<b>Product Change Notification for the Phoenix Contact Sales Net</b>	<b>FS A-7-0051</b> <b>R-Index -01-</b>

Business Unit 1) 2)	Product line 1) 2)	Product key 1) 2)	Change no. 1) 2)	Author's code (User-ID) 1) 2)	Date of establishment 1) 2)
IF	CK7		ACK170065	PYBM03	2018-04-30

Brief description of the modification 1) 2)
Design change according to new corporate guidelines/standardization

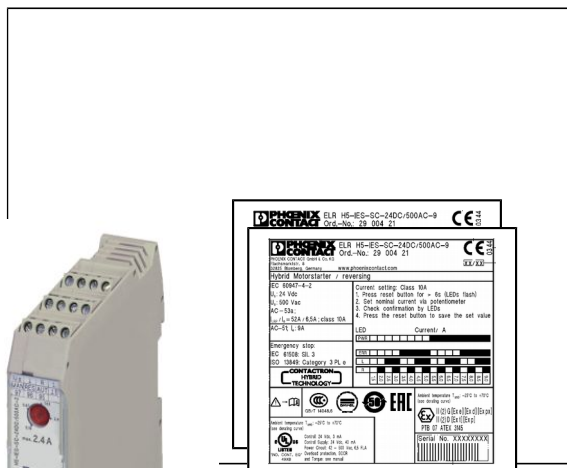
Detailed description of the modification
According to new corporate guidelines the product appearance will change; This means all products, which are listed in the article list (see attachment), will get a standardized printing. Products of the product family CONTACTRON will change into housing color RAL 7042 (see attachment)

S 1)	an still be used:	<input checked="" type="checkbox"/> yes <input type="checkbox"/> no
	Plate background RAL 9010	Plate background RAL7035	<input type="checkbox"/> yes <input checked="" type="checkbox"/> no
	Presumable first product(s) (Qu., Week or date):	2018-12-01
